| <b>Project:</b>        | A63 Castle Street Improvement, Hull              |                  |            |
| <b>Document title:</b> | Additional Flood Risk Information Technical Note |                  |            |
| <b>Document ref:</b>   | HE514508-MMSJV-EWE-S0-RP-ZH-000001               | <b>Revision:</b> | V2.0       |

Figure 25: Copy of figure 15 from Hull City Council Strategic Flood Risk outlining required levels for places of safety during a flood

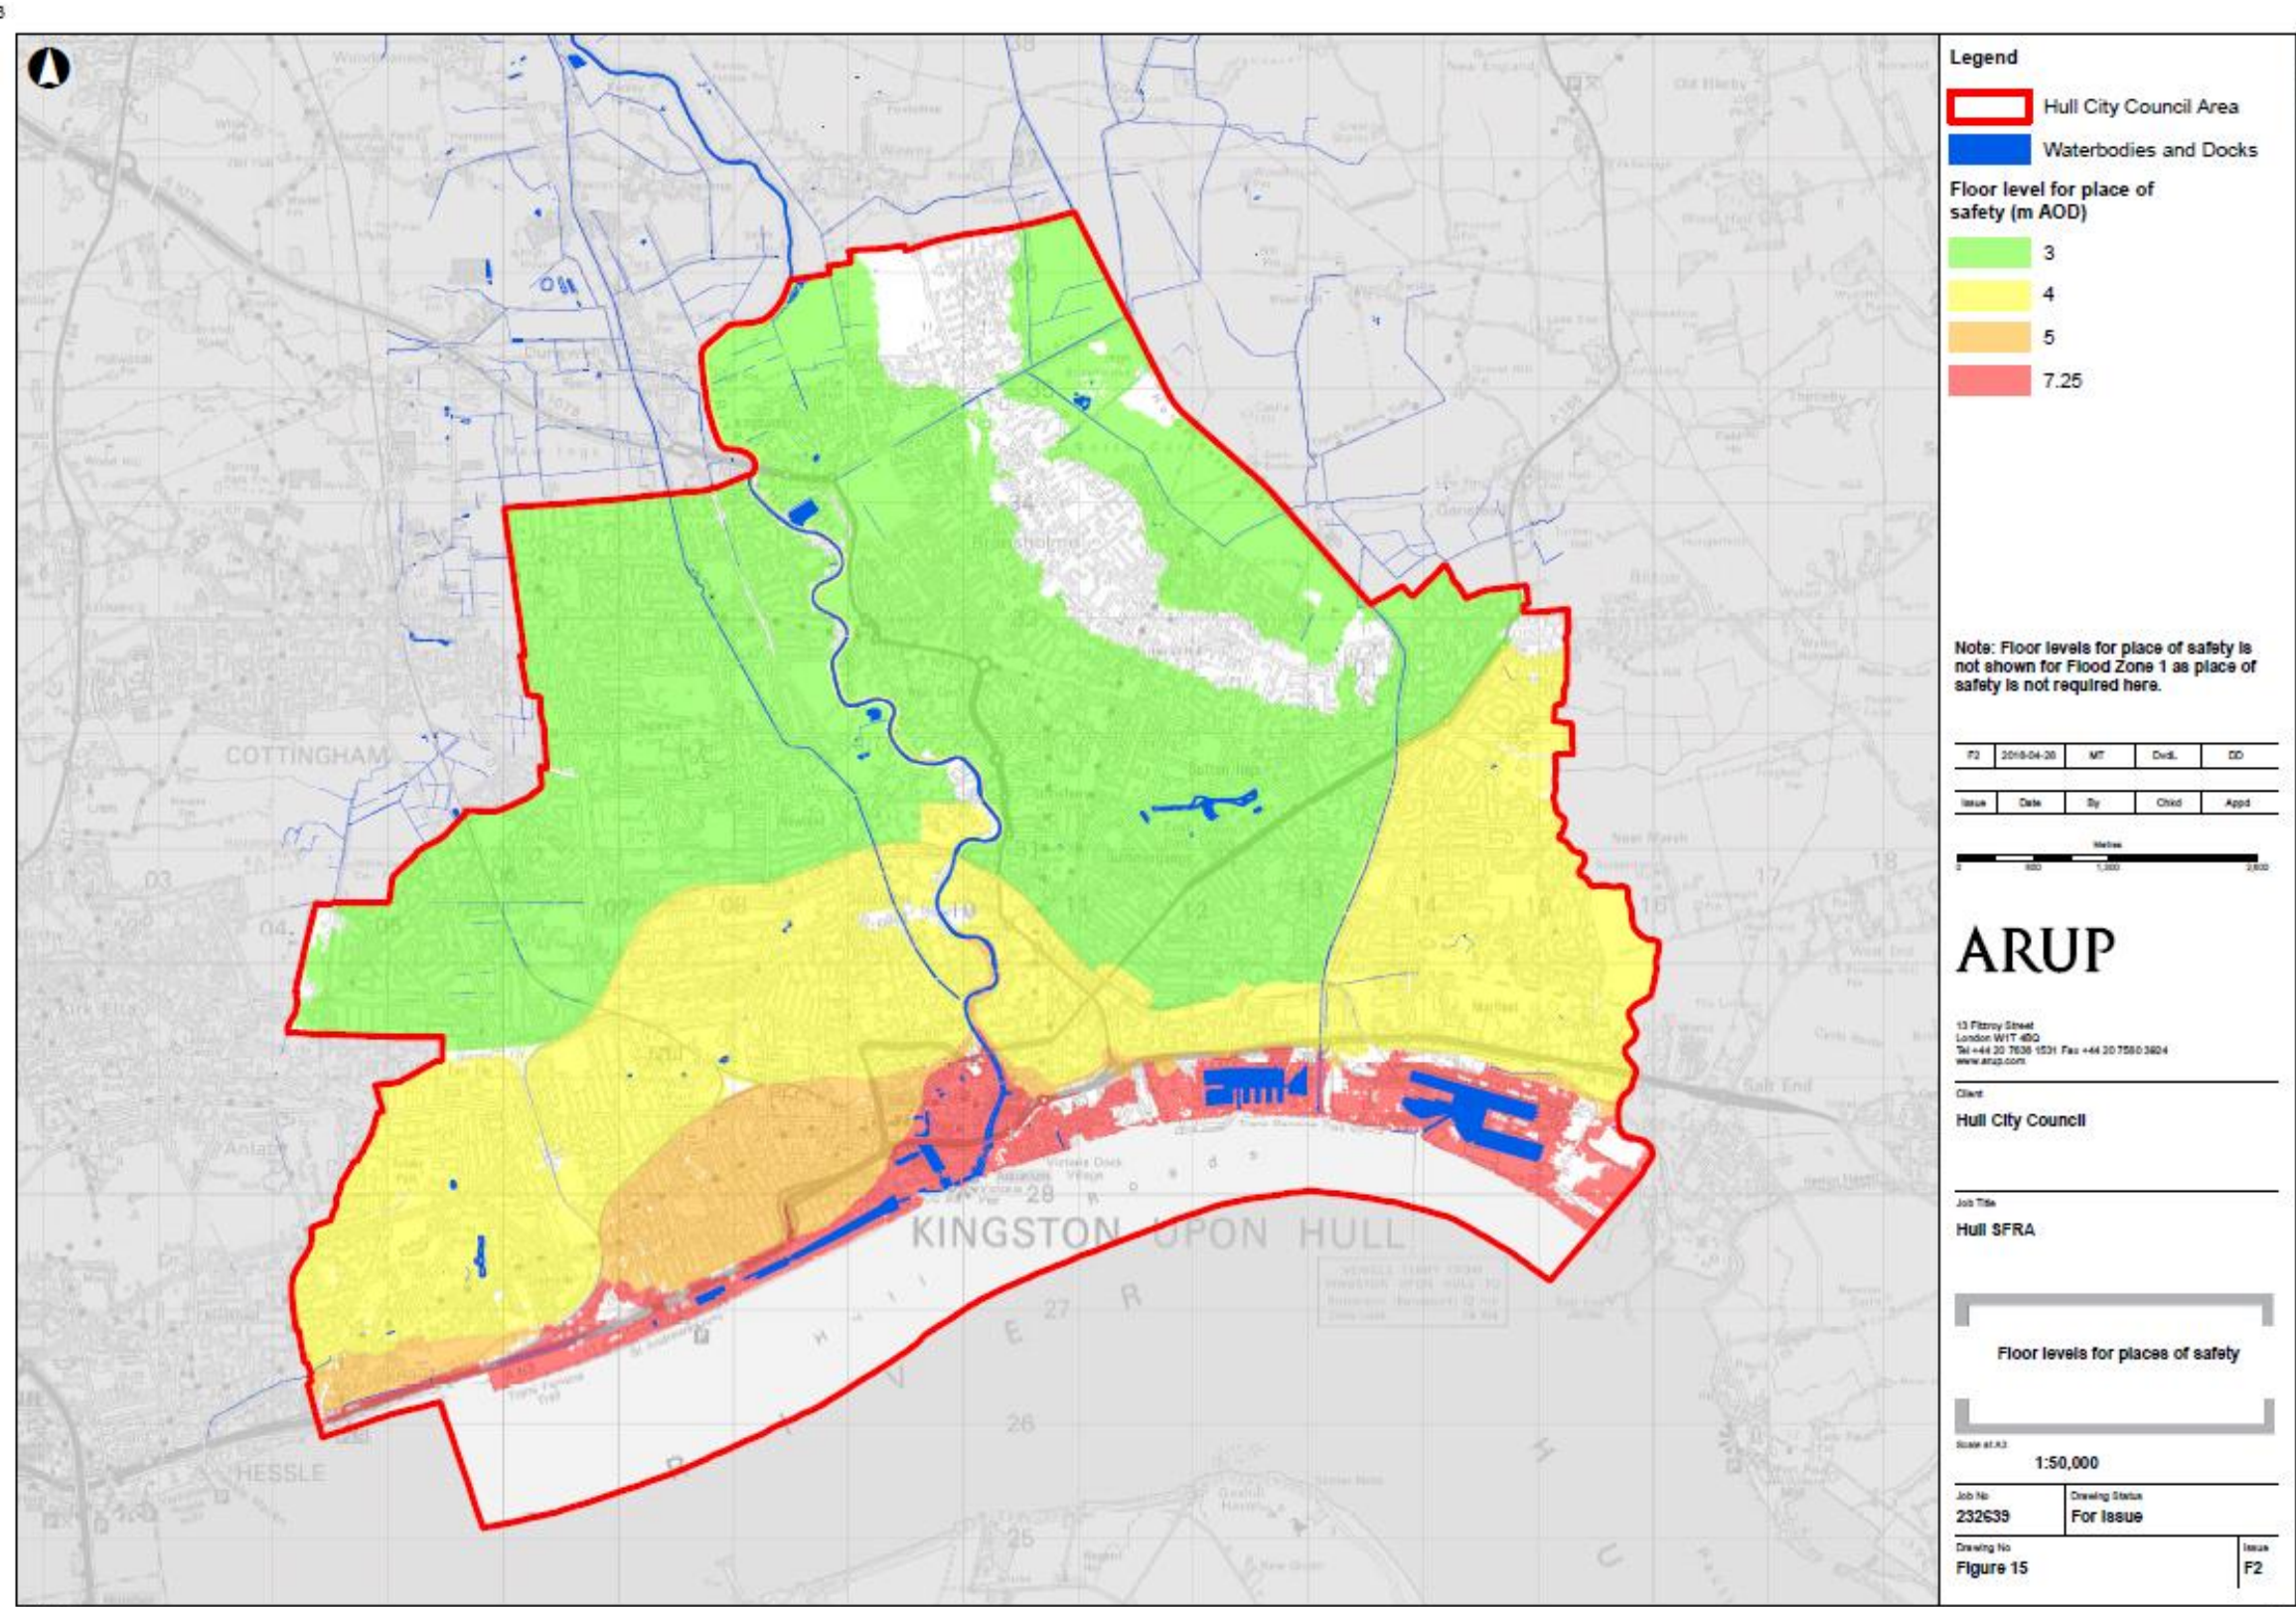
*'...consider the requirement for a place of safety for compound site users. Any proposed place of safety must be above the level shown in Figure 15 of the SFRA. The FRA must consider how this will be accessed during a flood. It is recommended that site users are signed up the Environment Agency flood warning service.'*

- Any flood sensitive temporary structures will be constructed in a flood resilient way, where appropriate.
- Figure 15 of the Hull City Council SFRA (see Figure 25 below) provides the following levels for places of safety:

- 5.00m AOD for the Staples, Arco, and Myton Centre Parking compounds
  - 7.25m AOD for the Wellington Street Island Wharf, A63 eastbound recovery base, A63 westbound recovery base, the land south west of Mytongate Junction and the Neptune Street Set Down compounds

- The Livingstone Road compound falls out with the Hull City Council SFRA study area and no place of safety level is available for this compound. The 2014 Interim Water Level Profile provides data at Hessle (location H215). The estimated water level for a 1 in 100-year event (as stipulated in the Hull City Council SFRA as a requirement for the place of safety) is 6.06m AOD at Livingstone Road. Therefore, the OEMP should include provision of a place of safety above this level.
